ADDENDUM NO. 05

PROJECT NAME: McAllister Park
TCI PROJECT NO.: 40-00375
DATE: February 16, 2015

SPECIFICATIONS FOR CONSTRUCTION OF MCALLISTER PARK RENOVATIONS 40-00375

1 CONCRETE SIDEWALK
 SCALE: 1"=1'-0"

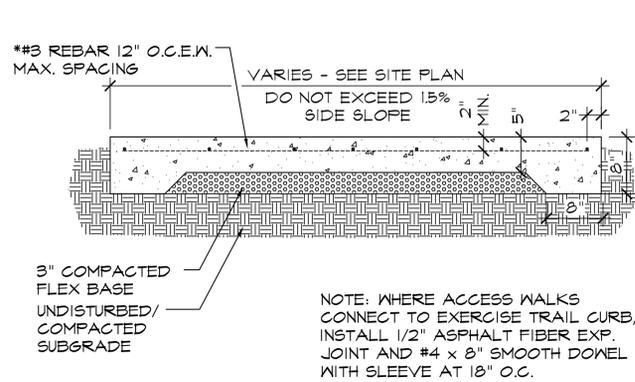
13. Concrete Sidewalks – The details for Concrete Sidewalks is different on Sheet C-9.0 and L5.1. Which one governs?

Response: The landscape architect's detail, 1/L5.1, governs for the construction of sidewalks. Disregard civil detail on sheet C-9.0.

3 TOOLED CONTROL JOINT
 SCALE: 1"=1'-0"

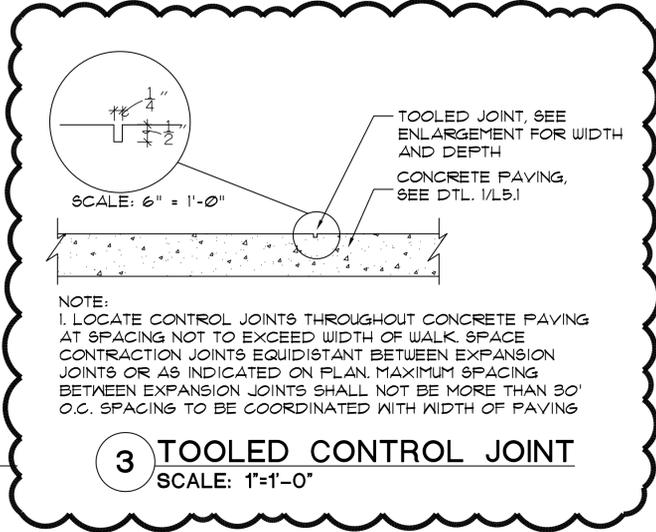
15. Detail 3/L5.1 is titled "Sawcut Control Joint" yet the joint is described as a tooled joint within the detail. Please confirm whether the joint is sawn or tooled.

Response: The joint is to be tooled.

7 BOLLARD POST
 SCALE: 1/2"=1'-0"

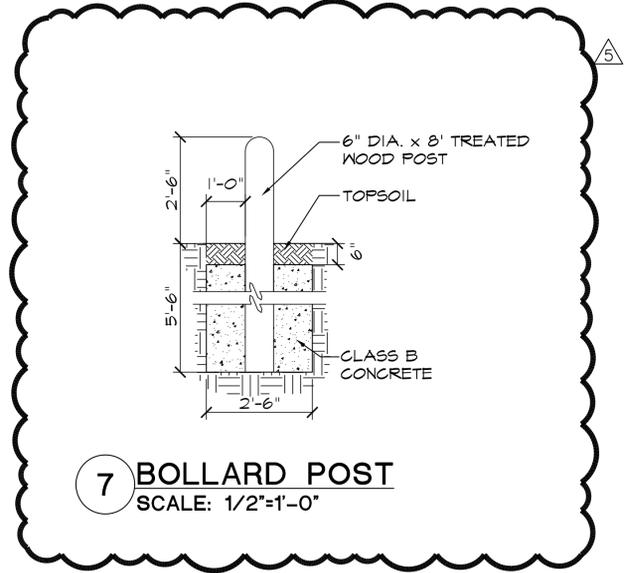
17. Detail 7/L5.1 describes the Bollard Posts of which there are many on the project. What determines whether a post is a terminal posts or a line post.

Response: All bollard posts are to have concrete footings. See updated detail 7/L5.1.

9 ASPHALT TRAIL W/ FLUSH CURB
 SCALE: 1"=1'-0"

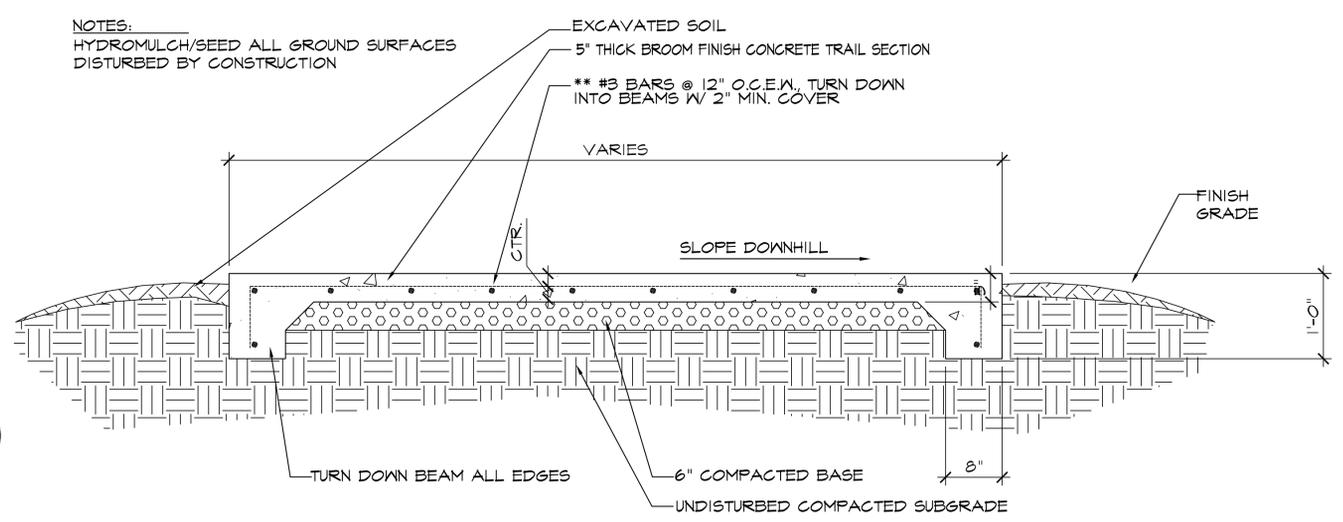
14. Concrete Flush Curb – There are no details for reinforcing steel for the Concrete Flush Curb on Sheet C-9.0 nor L5.1. Please provide details or confirm that there is no reinforcing steel in the Flush Curbs.

18. Detail 9/L5.1 for new Asphalt Trails w/ Flush Curb, it appears that there is only curb on one side of the trail. Please confirm.

Response: There is continuous #4 bar in the flush curb. See updated detail 9/L5.1.

Response: Certain areas of the asphalt trails have a concrete curb on online one side to prevent erosion damage. Refer to note #14 on landscape architect's site plan (L2 series). Concrete curb is located on the north/west side of the trail in these areas.
